UNITED STATES PATENT AND TRADEMARK OFFICE

APPLICATION NO.	FILING DATE	FIRST NAMED INVENTOR	ATTORNEY DOCKET NO.	CONFIRMATION NO.
10/001,708	10/18/2001	John B. Stoick	2267.629US01	2958
24113	7590 04/20/2005		EXAMINER	
	ON, THUENTE, SKAAR &	ALIE, GHASSEM		
4800 IDS CE 80 SOUTH 8			ART UNIT	PAPER NUMBER
MINNEAPOLIS, MN 55402-2100			3724	
			DATE MAILED: 04/20/200	5

Application No.	Applicant(s)			
	10/001,708	STOICK ET AL.			
Office Action Summary	Examiner	Art Unit			
·					
The MAILING DATE of this communication app	Ghassem Alie	3724			
Period for Reply	ears on the cover sheet with the c	orrespondence address			
A SHORTENED STATUTORY PERIOD FOR REPLY THE MAILING DATE OF THIS COMMUNICATION. - Extensions of time may be available under the provisions of 37 CFR 1.13 after SIX (6) MONTHS from the mailing date of this communication. - If the period for reply specified above is less than thirty (30) days, a reply - If NO period for reply is specified above, the maximum statutory period w - Failure to reply within the set or extended period for reply will, by statute, Any reply received by the Office later than three months after the mailing earned patent term adjustment. See 37 CFR 1.704(b)

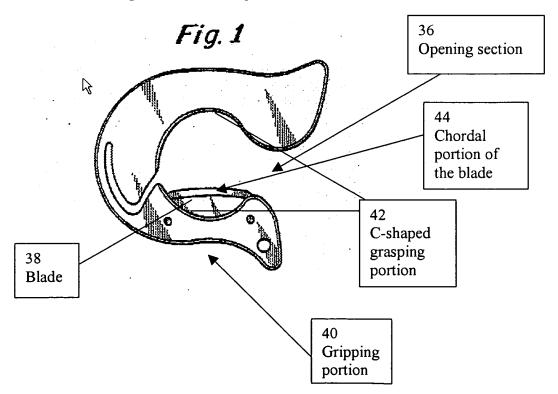
Regarding claims 12 and 13, Hockfeld teaches everything noted above including that grasping portion 42 makes substantial surface contact around the circumference of the tubing a distance necessary to forcefully receive the tubing. A tubing with slightly larger diameter than the grasping portion inherently could be snapped into the spaced within the grasping portion. Hockfeld also teaches that the contact around the circumference of the tubing is a distance between 51 to 75 percent of the circumference of the tubing. See Fig. 1 below.

6. Claim 1-4, 6-10, and 15-20, as best understood, are rejected under 35 U.S.C. 103(a) as being unpatentable over Hochfeld in view of Baltuch (2,254,199), or Mancini (Des. 362,168). Regarding claim 1, Hochfeld teaches a cutter that is capable of snapping onto and circumferentially grasp plastic tubing to facilitate the rotational cutting of the tubing. Hochfeld also teaches a cutter body and a C-shaped grasping portion 42 formed in the body and grasping portion 42 includes an opening 36 and a tube receiving portion. Hochfeld also teaches that opening 36 has a width generally less than the width of the tube receiving region such that C-shaped grasping portion 42 receives the plastic tubing with snap engagement retains the plastic tubing during the cutting of the tubing. The opening section of the grasping portion has a width less than the tube receiving region of the grasping portion such that plastic tubing needs to be forced onto the opening section in order to be placed within the tube receiving region of the grasping portion. Hochfeld also teaches a non-movable blade 38 secured to the body such that a chordal portion 44 of the blade extends into the grasping portion whereby rotational movement of the engaged cutter around the outer surface of the tubing facilitate cutting. It should be noted that grasping portion 42 has a circular-shaped receiving portion and non-movable blade 38 extents into the grasping portion. A chordal portion 44 of the blade extends into the circular-shaped receiving region of grasping portion 42 in the same manner that a chordal portion of the blade extents into the grasping portion in the instant invention. See Fig. 1 in Hochfeld and the instant invention. See Fig. 1 below.

Regarding claims 2-4 and 6, Hockfeld teaches everything noted above including that the inner diameter of C-shaped grasping portion 42 is smaller than the outer diameter of the tubing. A tubing with slightly larger diameter than the grasping portion inherently could be snapped into the spaced within the grasping portion. The rotational movement of the cutter inherently cuts the tubing a distance short of the thickness of the tubing. Hockfeld also teaches that the blade 38 is a single-edged razor blade. See Fig. 1 above.

Regarding claim 15, Hockfeld as modified above teaches everything noted above including a gripping portion 40 formed in the body by at least one arcuate depression for human handing of the cutter. See Fig. 1 above in Hockfeld.
